Oklahoma Department of Wildlife Conservation

Amendment of Solicitation

Solicitation No. 011S

Solicitation for the ODWC courtesy dock at Jap Beaver lake Amendment Continued:

DESIGN #6 - 4 TELESCOPES

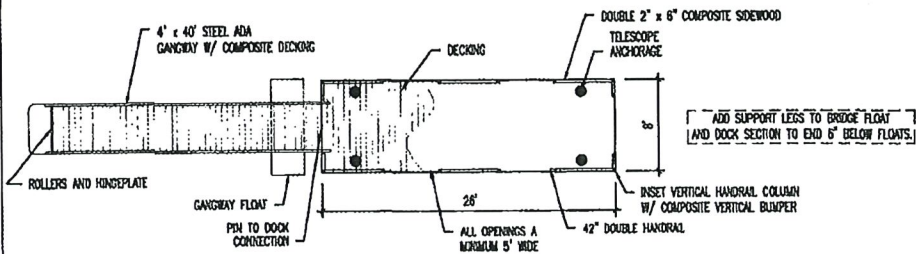
- Are there to be any gaps in the dock handrail for people to get on and off of their boats, and if so where should they be located?
 - Yes, there should be at least one opening in the handrails with a minimum width of 5ft on each side of the courtesy
 - Please reference Design #6 in Attachment A of the

- Does this mean that the anchors need to be within the footprint of the dock's 8' x 26'? Or can the anchors be on all 4 corners outside the handrail and 8' x 26' footprint?

- The anchors should be within the footprint of the courtesy dock
 - Please reference Design #6 in Attachment A of the

The dock system will consist of a 40ft x 4ft gangway and an 8ft x 26ft courtesy dock with four (4) telescoping pencil anchors (see Design #6 in Attachment A).

- Galvanized 8" dock cleats shall be installed under the handrails 2 feet and 14 feet from the terminal end of the dock
- Dock handrails shall be a 2-inch diameter top rail at 42-inch height, with a mid-rail at 20 inches above the deck (see Attachment B), and shall be located per Design #6 in Attachment A.
- Dock handrails shall not extend beyond the boat dock substructure.

ATTACHMENT B

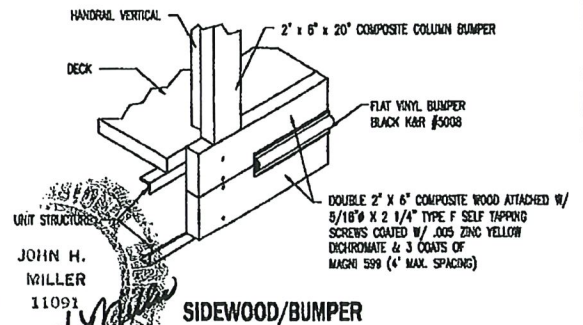
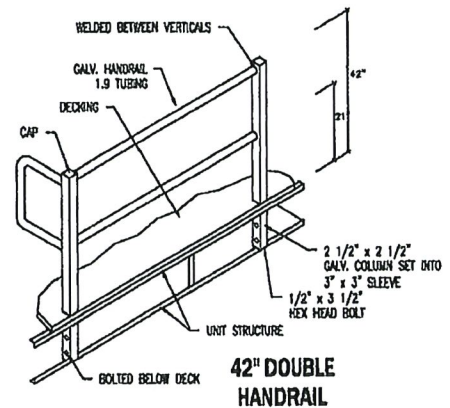
Question: Under Dock Decking, Handrails, Fenders, Bumpers, it mentions a diagram B for reference, but there is no Diagram B attached to the document.

Answer: The attached Specs have been updated from the original and added the Drawings, as Attachments A, B & C for reference.

- Fenders shall be without gaps and extend from the deck to no less than 8 inches above the water surface (see Attachment B).
- A bumper of recycled plastic lumber with UV inhibitors shall be centered along the fender (2" x 8" nominal Markstarr #28144 or equal) attached with 5/16" x 2 ¼" flat head, Type F, self-tapping screws coated with 0.005 zinc-yellow dichromate and three coats of magni 599, recessed minimum of 1/2". Hollow bumpers will not be accepted.
